22463 I-70 Genoa East and West Pavement Reconstruction Project Final Value Engineering Report

Prepared For:
 **COLORADO**
Department of Transportation

Date: January 2020

VE PROPOSAL VE-2	
PROJECT: 22463 I-70 Genoa Pavement Reconstruction Project	Idea No.: 3 Date: July 11 th , 2019
DESCRIPTION OF VE PROPOSAL: Re-evaluate the concrete design	Page No.: 2 of 5

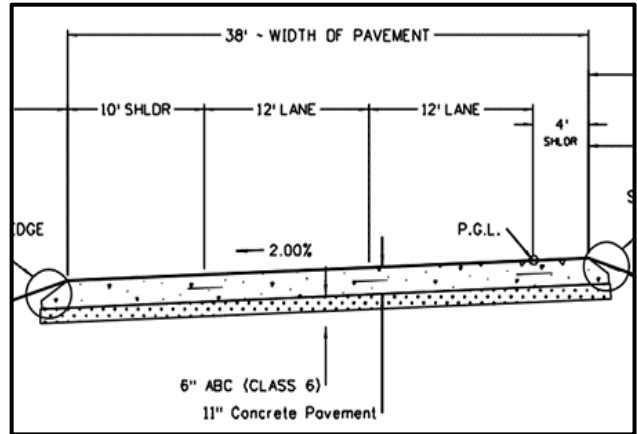
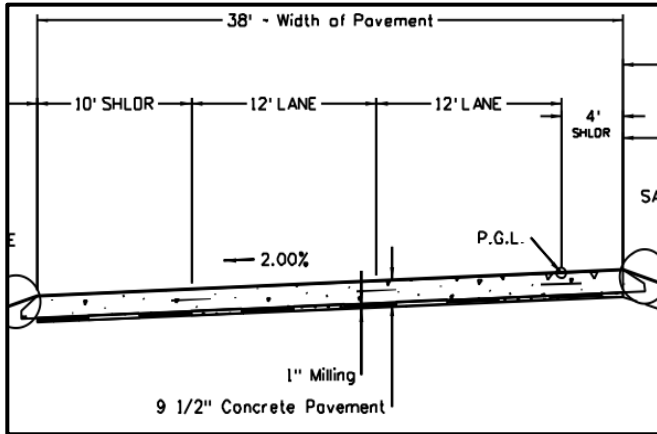
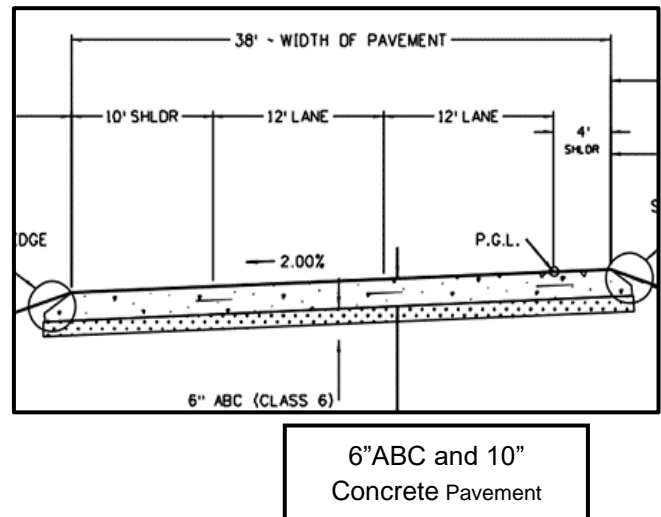
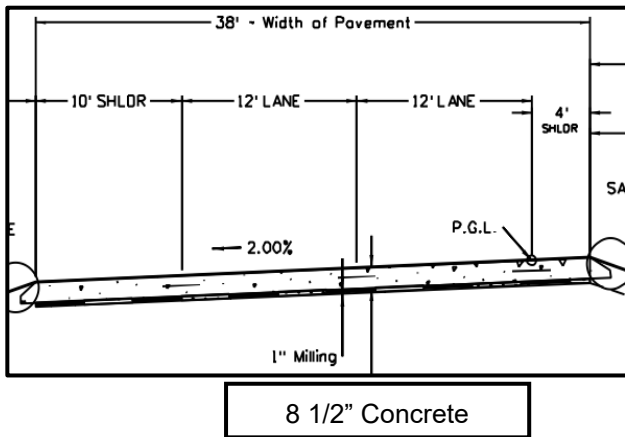
The proposed design has the potential to increase the amount of transverse cracking thus reducing service life compared to the base case design. However, the proposed design meets the 27-year distress threshold as per CDOT 2020 Pavement Design Manual. It would also require time and costs to redesign what is currently shown in the plans.

We have performed site specific designs analyzing the proposed change. Performing site specific designs, many of the site designs were already designed to CDOTs minimum Design Life standard of 27 years. Unless it is desirable to change thickness of concrete on a regular basis throughout the project limits, and differing in both directions also, we recommend utilizing the originally proposed design thickness. It is our opinion that there will be negligible cost savings switching thicknesses on a regular basis while increasing CDOTs risk for construction and design related deficiencies.

VE PROPOSAL VE-3	
PROJECT: 22463 I-70 Genoa Pavement Reconstruction Project	Idea No.: 4 Date: July 11 th , 2019
DESCRIPTION OF VE PROPOSAL: Optimize milling	Page No.: 2 of 3

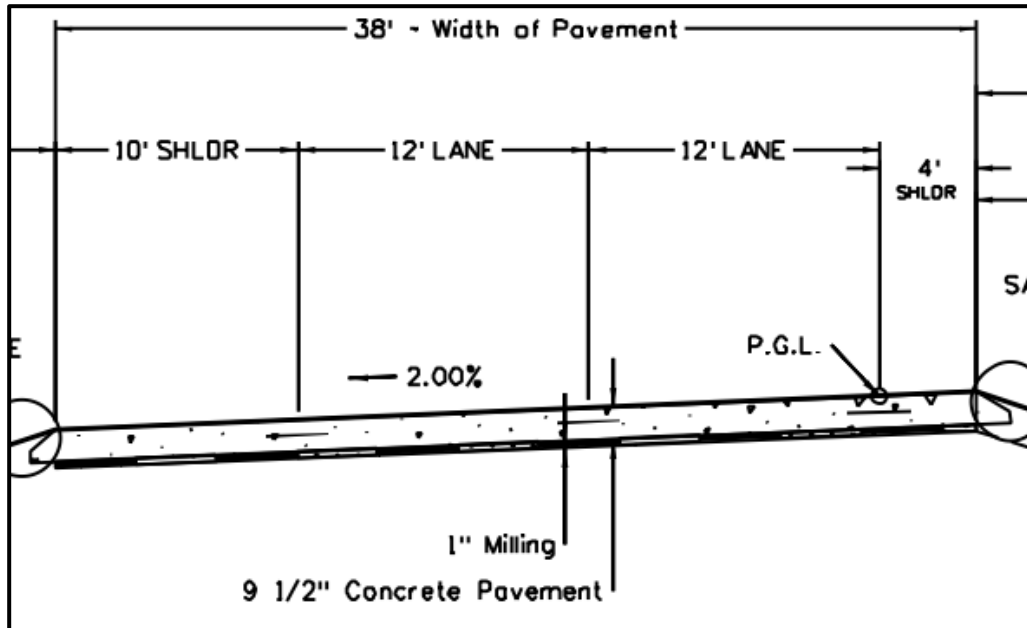
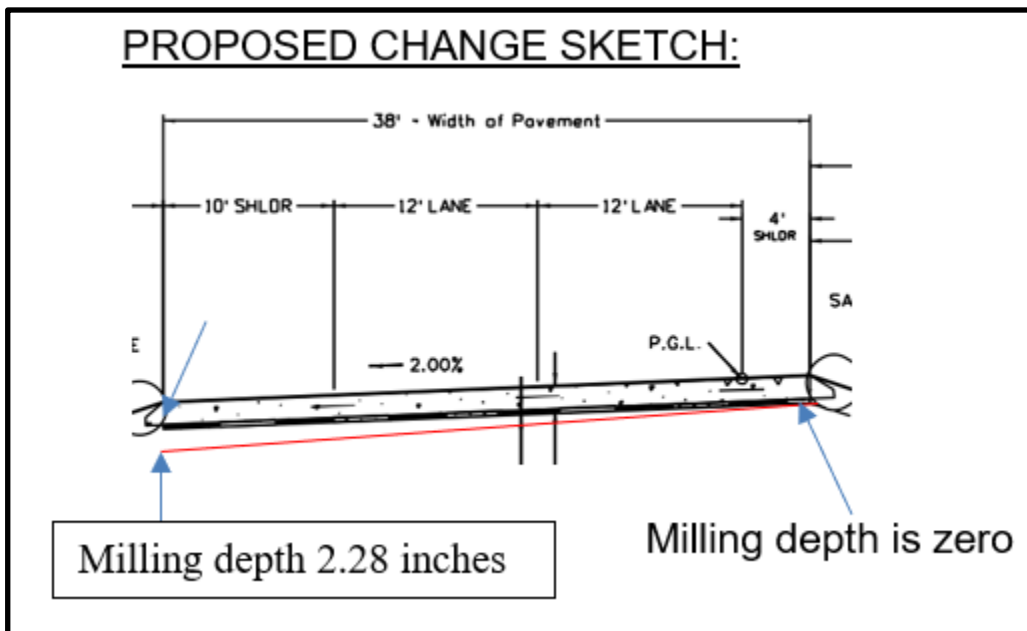
Based on the current thickness of the HMA, milling the cross-slope will not impact the minimum HMA thickness needed to support the PCCP. Only milling required sections of the existing HMA could accelerate the Contractor's schedule and minimize the Contractor's risk of placing additional concrete to meet the required cross-slope. The current HMA surface will provide an adequate bond due to the age of the HMA.

Accurately surveying the current cross-slope has a potential to delay the delivery of the project. However, funding for this project has not been allocated. It would require time and increase the cost to redesign what is currently shown in the plans. The additional depth of milling in the shoulder locations may increase the possibility of unstable subgrade.

VE PROPOSAL VE-4	
PROJECT: 22463 I-70 Genoa Pavement Reconstruction Project	Idea No.: 12 Date: July 11 th , 2019
DESCRIPTION OF VE PROPOSAL: Use widened lanes	Page No.: 3 of 4

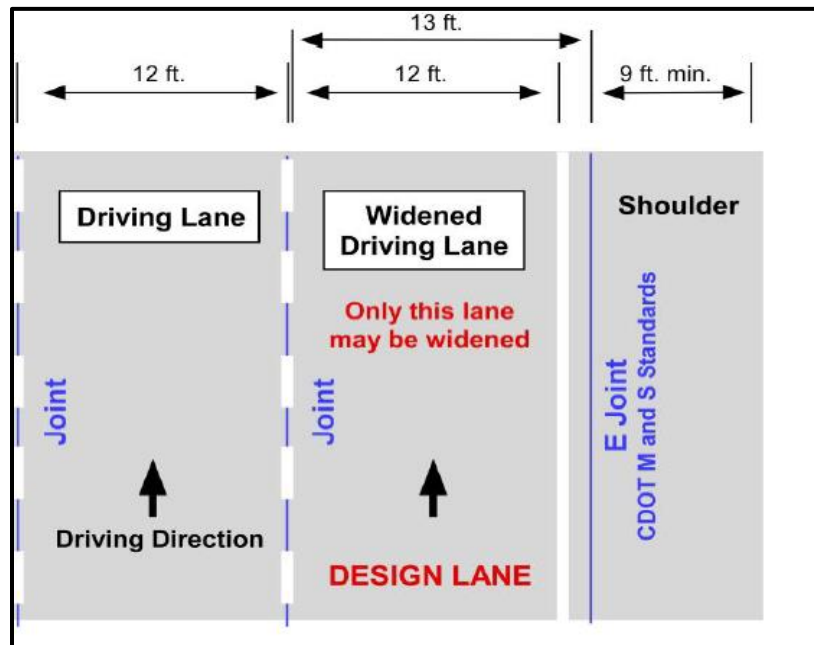
The widen lane is a current CDOT design standard. Widened slabs have been used to mitigate transverse cracking in Jointed Plane Concrete Pavement (JPCP) because edge load compared to interior and corner loads usually produces the highest stress on Jointed Plane Concrete Pavement. By using widened slabs, load is not applied to slab edges, so the transverse cracking potential is diminished. Finite element models have shown that stress is highest at the longitudinal joint nearest to the free edge. Therefore, the longitudinal joint nearest to the outside shoulder becomes the critical joint. In 1994, a study was conducted on Interstate 70 in Colorado near the Colorado-Kansas border to examine the effects of tied PCC shoulder and widened slabs (14-foot slabs). The results indicated that the measured strains dropped significantly in the 14-foot wide lane as compared to the 12-foot wide lane. CDOT started using the 14-foot wide slabs in 1995 on I-70 from milepost 348.2 to milepost 358.1.

The shoulder would need to be removed and replaced if the current shoulder becomes a future driving lane.

We have evaluated the proposal to widen lanes, in several ways, to determine the feasibility and risk associated with this change. Currently in the Mechanistic Empirical Pavement Design Guide Manual of practice, it states *“Wider slabs can be used for outside truck lanes to move the wheel path away from the edges and corner of the slab to reduce stresses in these areas. As little as a one foot widening has a significant effect. However, the potential for longitudinal cracking is increased with wider slabs, especially in thinner slabs (<10 inches), although AASTHO Ware Pavement ME Design does not predict longitudinal cracking.”* In conjunction with this and International Journal of Pavement Research and Technology 11(2018) *Longitudinal Cracking of Jointed Plain Concrete Pavements in Louisiana: Field Investigation and Numerical Simulation* by Danny Xiao and Zhong Wu, and IHRB Project TR-700 *Prevention of Longitudinal Cracking in Iowa Widened Concrete Pavement* (June 2018) for Iowa Highway Research Board Iowa DOT by Iowa State University (Specifically analysis between Pages 110-121), we feel that the risk of significant longitudinal cracking by utilizing widening of the slab in conjunction with thinning of the PCCP slab in Pavement ME is detrimental to the long term performance of the pavement. We propose to not allow utilization of Pavement ME and widening the slab as a method for decreasing the thickness of PCCP, as the primary expected failure mode (Longitudinal Cracking) is not currently feasible for evaluation using the Pavement ME program and could put CDOT at substantial risk for potential early deterioration from longitudinal cracking.

VE PROPOSAL VE-5

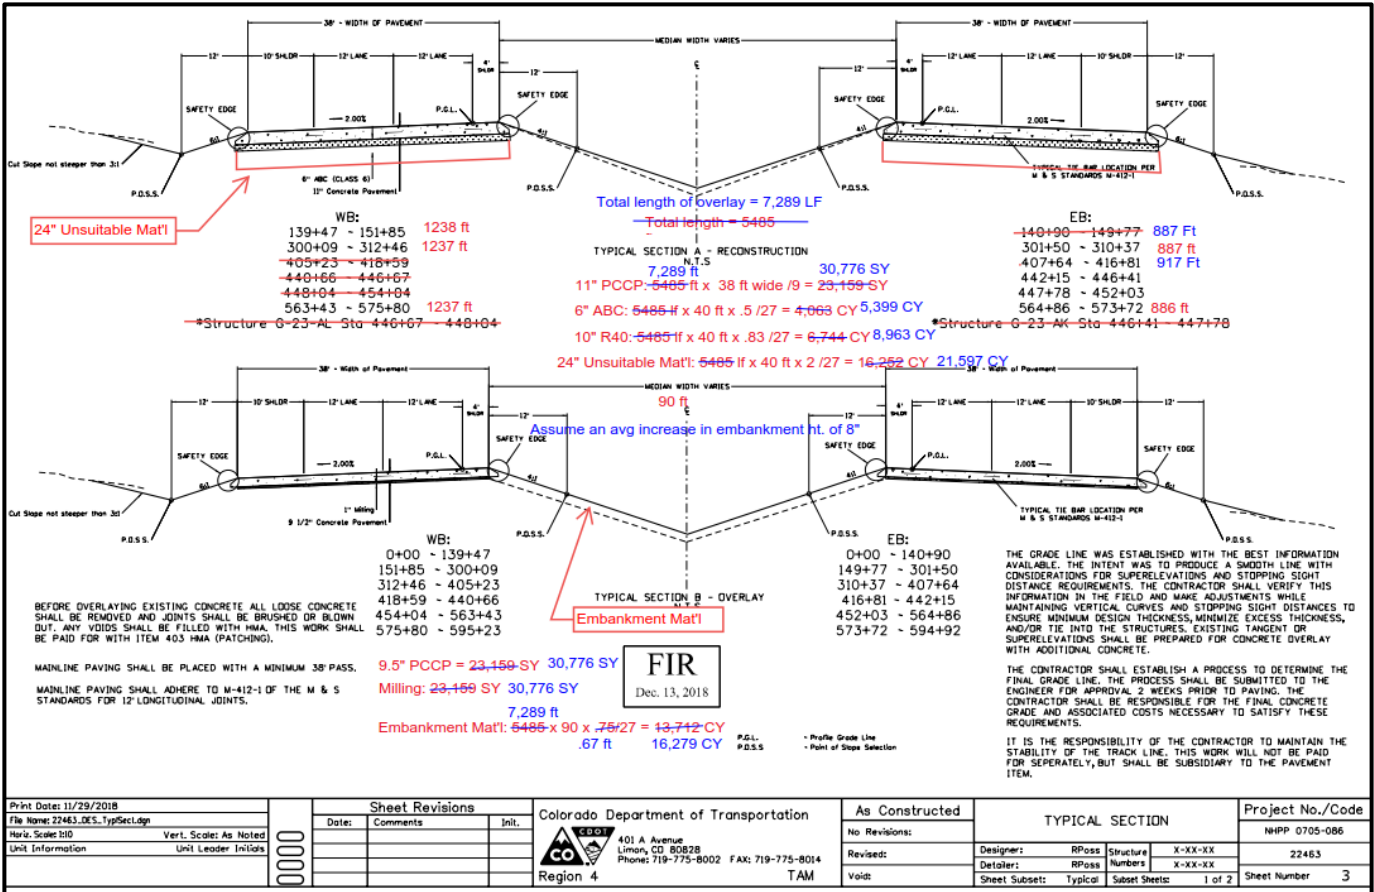
- May not provide excess vertical clearance but still meets the required standard

Structure No.	Direction	Existing Vertical Clearance	Existing HMA Thickness	Proposed Pavement Treatment	Net Profile Change	Resulting Vertical Clearance
G-23-AD	EB	16' 3"	10" - 15"	9.5" PCCP OVERLAY/ 6.5" MILLING	+3"	16' 0"
	WB	16' 9"	6.75" - 9.25"	9.5" PCCP OVERLAY/ 1" MILLING	+8.5"	16' 0.5"
G-23-AF	EB	19' 11"	12.25" - 16"	9.5" PCCP OVERLAY/ 1" MILLING	+8.5"	19' 2.5"
	WB	21' 11"	12.75" - 14"	9.5" PCCP OVERLAY/ 1" MILLING	+8.5"	21' 2.5"
G-23-AM	EB	16' 6"	12"	9.5" PCCP OVERLAY/ 3.5" MILLING	+6"	16' 6"
	WB	16' 1"	13"	11" PCCP/6"ABC/10" R40	0"	16' 1"
G-23-AG	EB	18' 8"	15" - 16"	9.5" PCCP OVERLAY/ 1" MILLING	+8.5"	17' 10.5"
	WB	21' 7"	12" - 13"	9.5" PCCP OVERLAY/ 1" MILLING	+8.5"	20' 9.5"

With modifications to VE Proposal 5 Minimum Vertical Clearances at Bridges, it is expected that only a minimal amount of unsuitable material will be generated for this project. Placement of unsuitable material on shoulders is not recommended due to errant vehicle concerns, however, the ultimate decision of use is to be determined by the Resident Engineer.

DESIGN COMMENT DC-1	
PROJECT: 22463 I-70 Genoa Pavement Reconstruction Project	Idea No. 5 Date: July 11 th , 2019
DESCRIPTION OF DESIGN COMMENT: Temporary lane closures	Page No.: 1 of 1

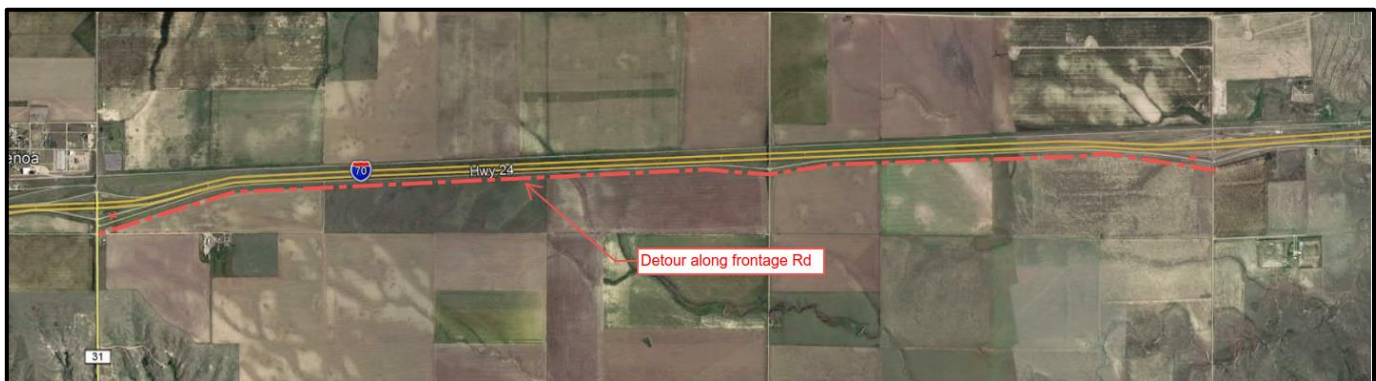
This option would allow the contractor to construct each ramp full width without the need to maintain and shift traffic. This should provide improved quality of the pavement construction, protect workers within the construction zone and reduce the potential for vehicle conflicts with construction traffic.

PROJECT: 22463 I-70 Genoa Pavement Reconstruction Project	Idea No.: 21 Date: July 11 th , 2019
DESCRIPTION OF DESIGN COMMENT: Use portable rumble strips during construction	Page No.: 1 of 1

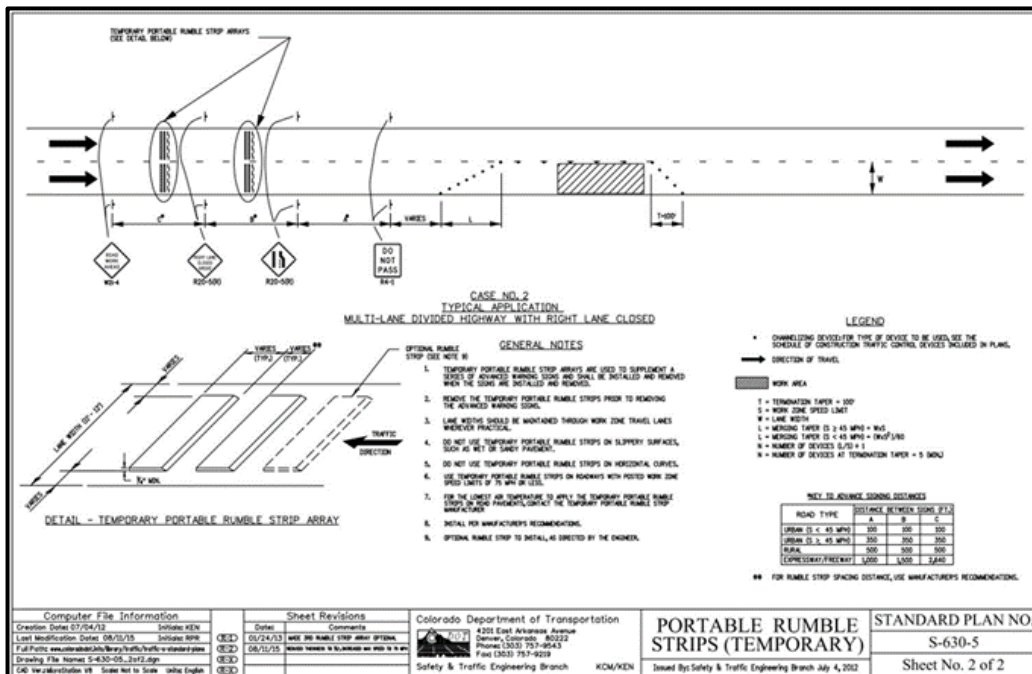
It was suggested that the item for portable rumble strips may be added to the project to enhance the traveling public awareness of entering a work zone.

By adding the item Portable Rumble Strips, it may help to alert drivers of pattern changes and enhance the traveling public awareness of entering a work zone.

DESCRIPTION OF IDEA:
Offset the permanent ramp alignments

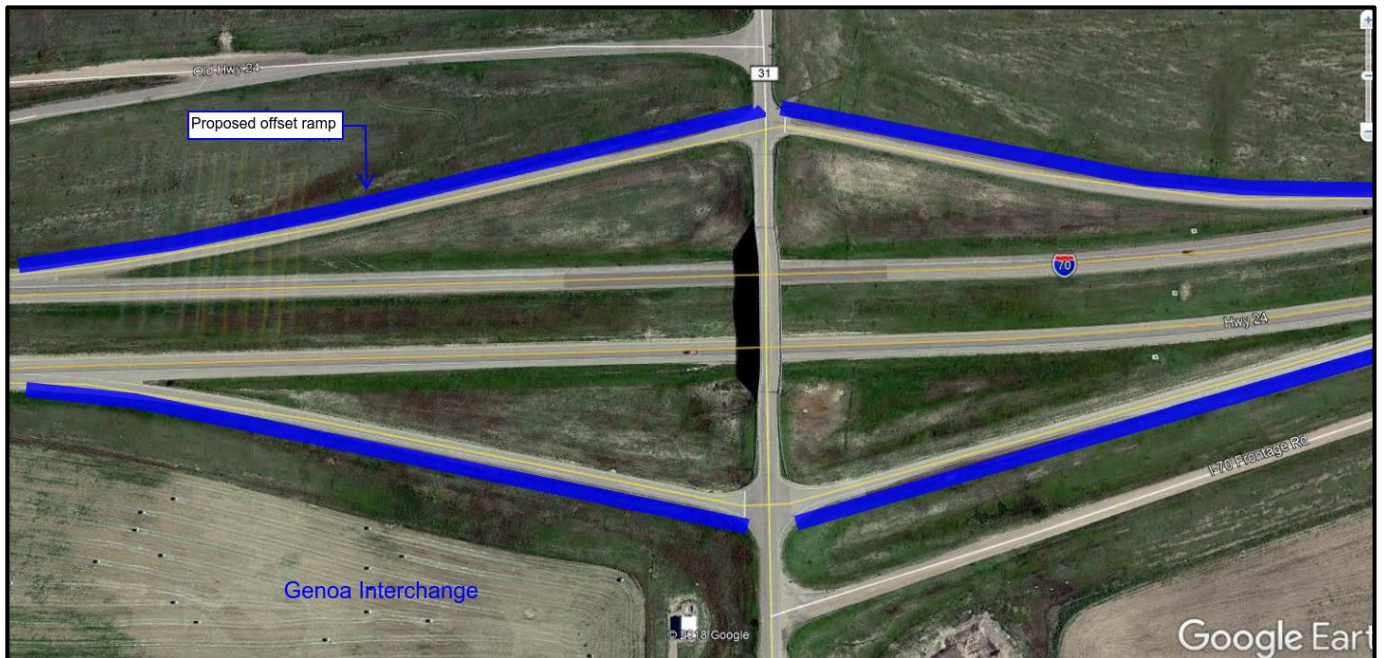
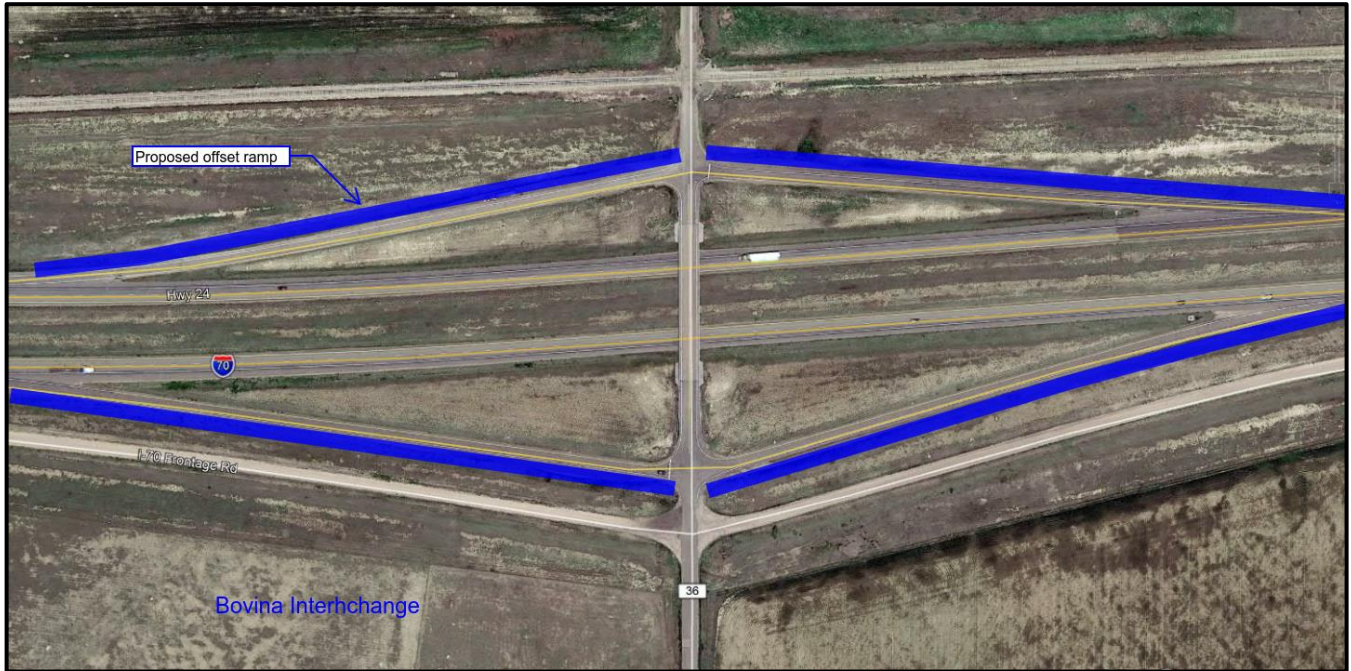
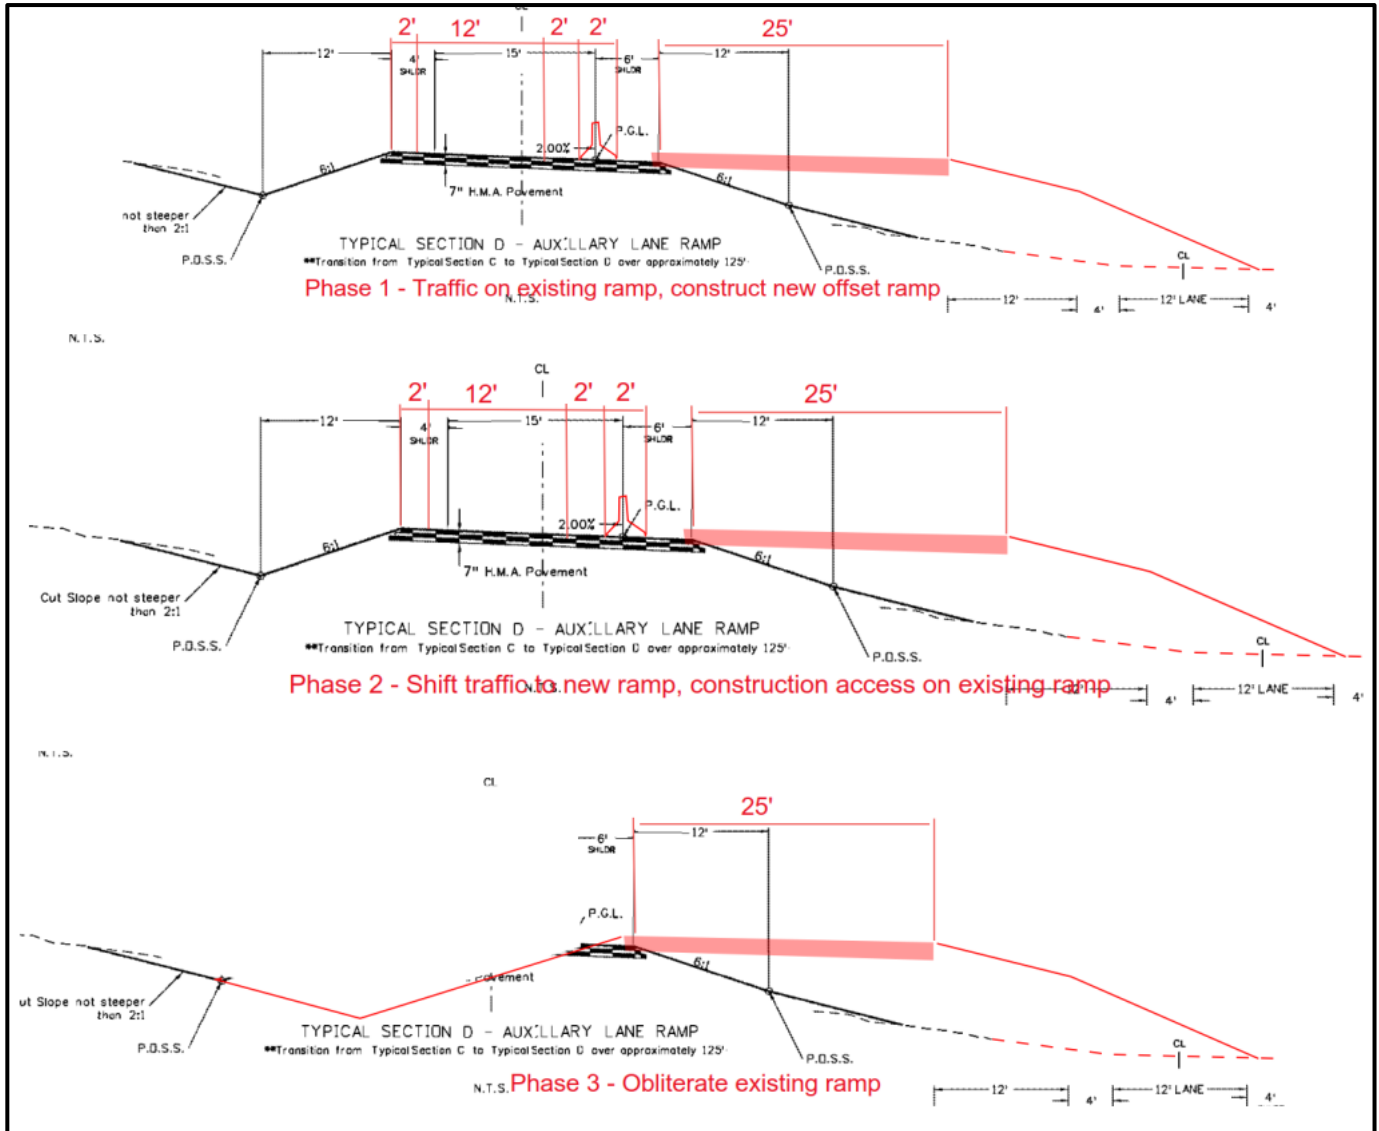
Proposed ramps at the Genoa and Bovina interchanges are currently planned to be reconstructed in their present location (i.e. no changes in alignment or profile). Proposed pavement structure will be 9” of PCCP over 6” of ABC. In order to construct the ramps, it will be necessary to either close the ramps temporarily and detour traffic, or to construct the ramps one half at a time. The ramps are used by both general traffic and construction traffic during construction which introduces the potential for accidents and conflicts.

This idea was dropped due to the significant additional cost per ramp.
